THE MEDICAL CENTER OF AURORA

19-009D TMCA MEDICAL DECISION UNIT

ISSUE DATE: 09 OCTOBER 2020
PROJECT #: 19-009D

City of Aurora Building Division
Reviewed for Code Compliance
Approved as Noted: *John Lichtner*
Date: *Dec 24, 2020*
2015 INTERNATIONAL CODES & 2020 NEC

01-LEVEL 01 - FLOOR PLAN
1/4" = 1'-0"

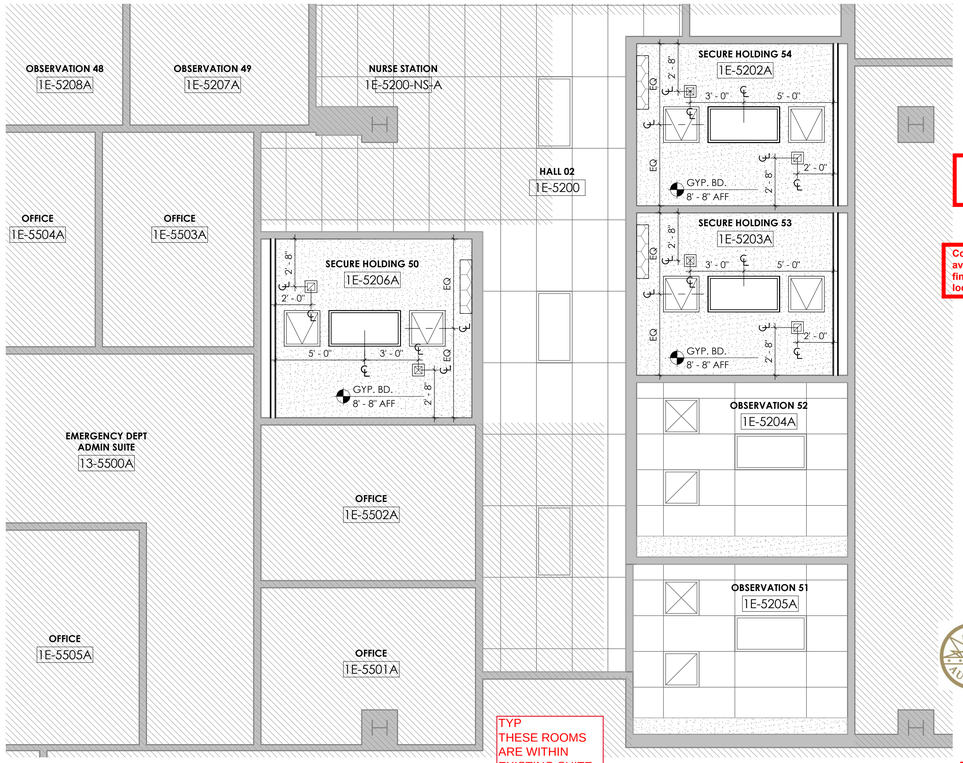
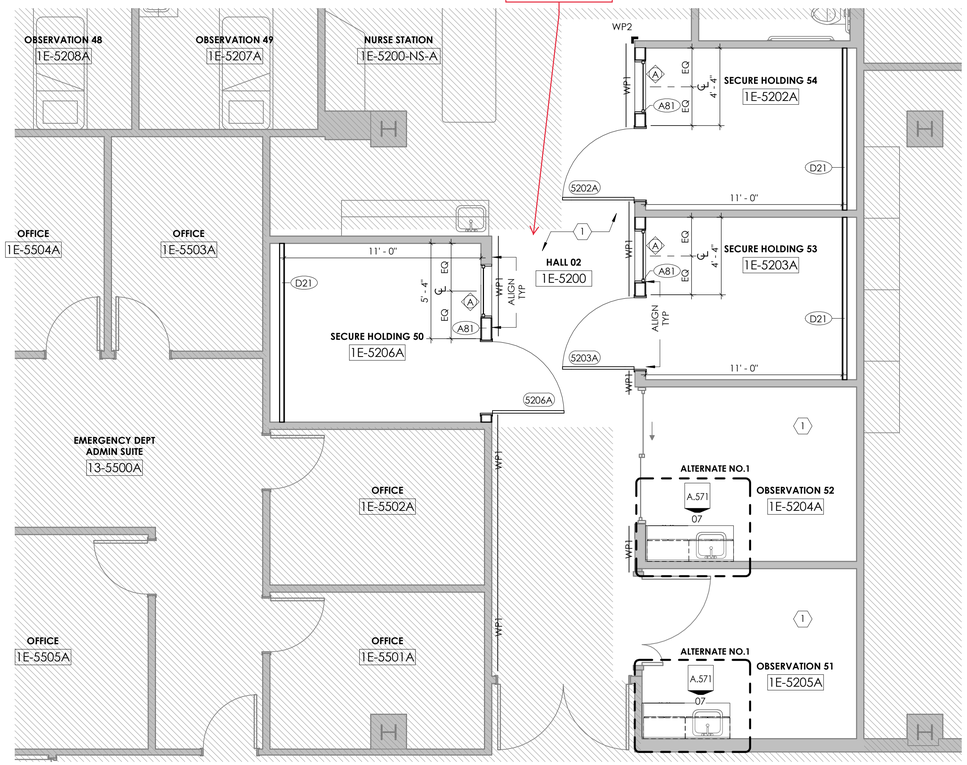
Provide U.L. Class 2A10BC minimum rating fire extinguishers at a maximum 50'-0" travel distance prior to the Certificate of Occupancy issuance 2015 IFC Table 906.3[1] and 2013 NFPA 10

Consultation for fire extinguisher placement is available upon request. Call 303-739-7420 prior to final Life Safety inspection to verify proposed locations.

1 LEVEL 01-MECHANICAL
1/4" = 1'-0"

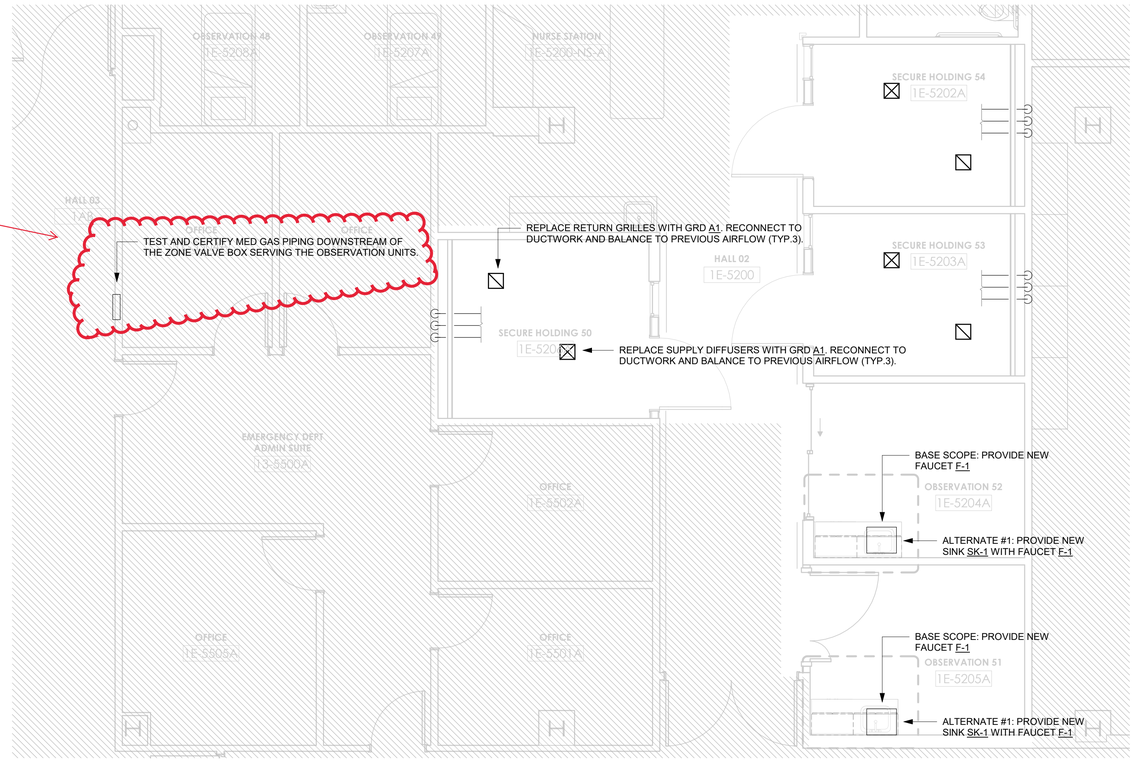
Provide proof of a flame spread less than 26 and a smoke development less than 50 for any material used in a plenum.
2015 IMC 602.2.1

Provide drains no smaller than allowed by **2015 IPC 709.1 and 710.1(1)**

2 LEVEL 01-ELECTRICAL
1/4" = 1'-0"

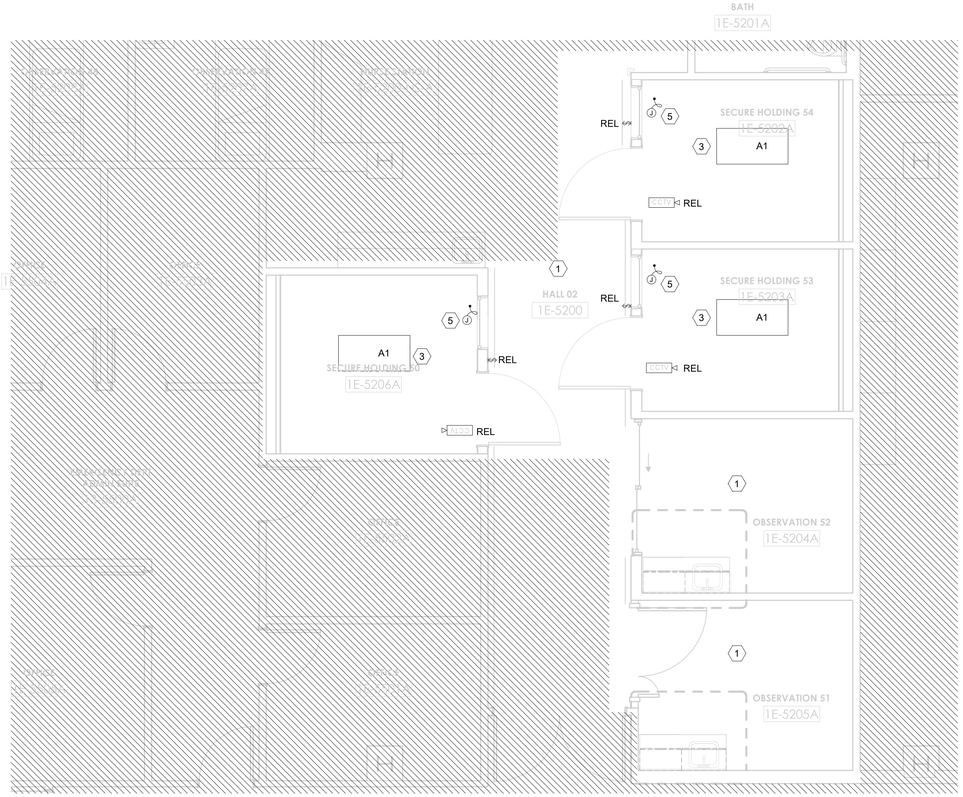
Provide Emergency Illumination Equipment That complies with 2020 NEC 700.12(F) or NEC 700.
